October 3, 1994

Docket No. 50-245  
B15002

Millstone Nuclear Power Station, Unit No. 1  
Response to Request for Additional Information  
Purge/Vent Valve Debris Screens

Figure 1 Atmospheric Control System

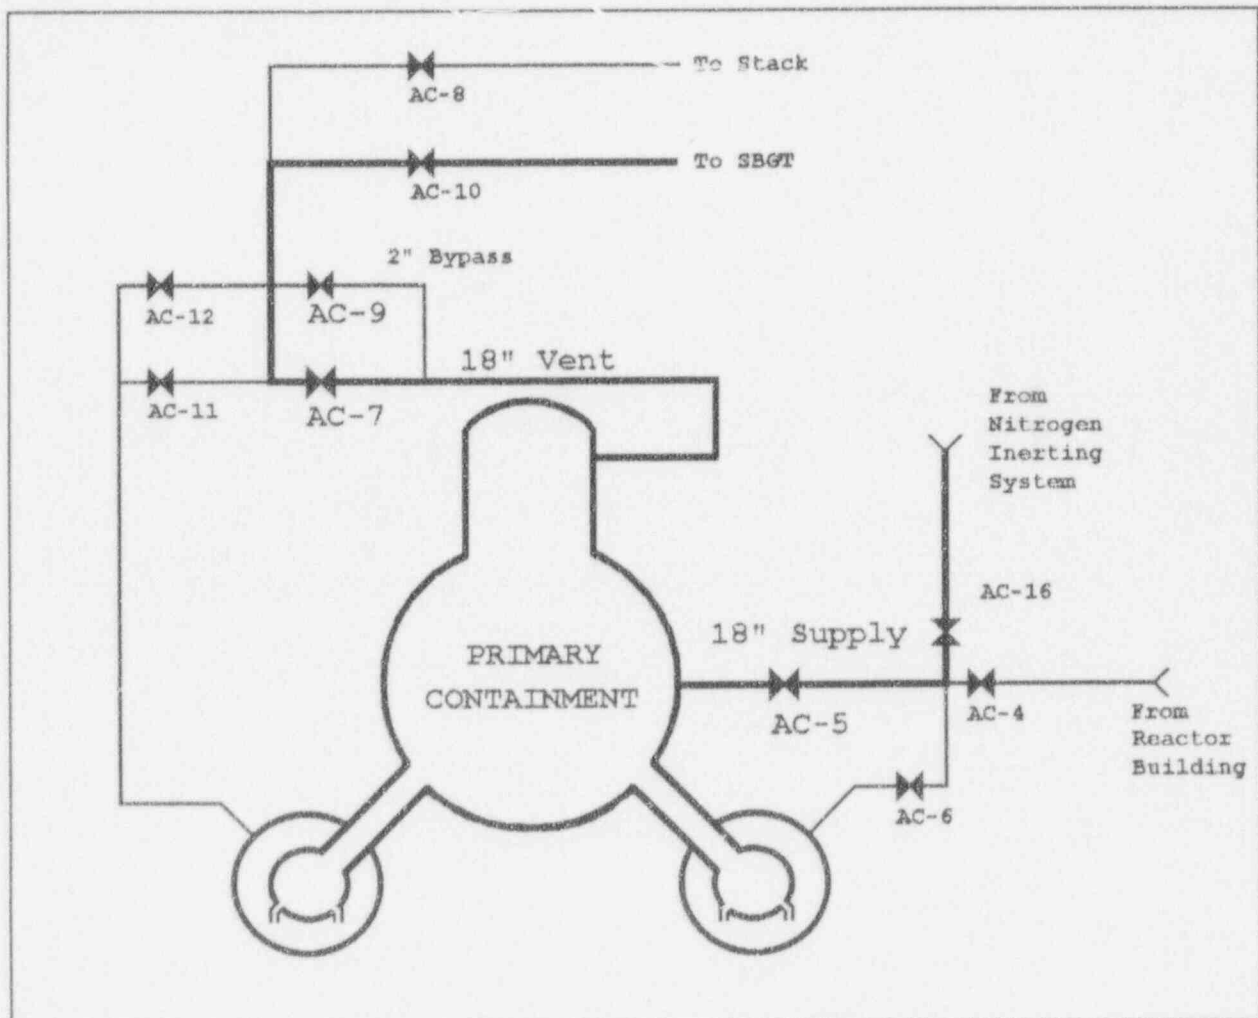
Nonetheless, following discussions with NNECO, the Staff recently revisited this issue and determined that NNECO had not submitted sufficient justification to support the position that debris screens were not necessary. The Staff requested that NNECO provide additional information on why screens are not needed. Accordingly, the basis for NNECO's determination that screens are of limited benefit is provided below.

At Millstone Unit No. 1, there are three valves which need to be addressed (see Figure 1): the 18-inch supply valve, AC-5; the 18-inch vent valve, AC-7; and the 2-inch (bypass) vent valve, AC-9. As stated in TMI Action Plan Item II.E.4.2 of NUREG 0737, the purge/vent lines on the torus would not be subjected to debris. Venting to the stack through AC-8 is not performed during power operation.

Piping configuration would preclude debris from reaching the valves.

The supply side drywell penetration is located at elevation 9'-1", which is approximately eight feet above the lowest floor in the drywell. Floor gratings separate the penetration from the two upper drywell levels. Debris from the upper level which moves downward following a design basis accident would be partially screened by the grating. Although debris could be generated from postulated breaks below the grating, there are no break locations postulated nearby, which would force debris into the penetration. Flow velocities inside the drywell due to the penetration are not expected to be high enough to direct debris into the piping. Outside of the drywell, the piping takes three right angle turns. These turns may also contribute to trapping debris before it reaches the valve.

The vent side penetration is located at elevation 68'-6". This is in the upper regions of the drywell. Immediately across from the penetration is the biological shield wall. There are no nearby

postulated break locations which would force debris into the penetration. The vent piping also takes right angle turns outside of containment. The turns may contribute to trapping debris before it reaches the valve.

The 2-inch bypass valve is tapped off the 18-inch line. This configuration forces the debris to take an additional right angle turn off the vent piping flow path. Also, the smaller diameter of the 2-inch line would preclude most debris from reaching the valve from the larger diameter piping.
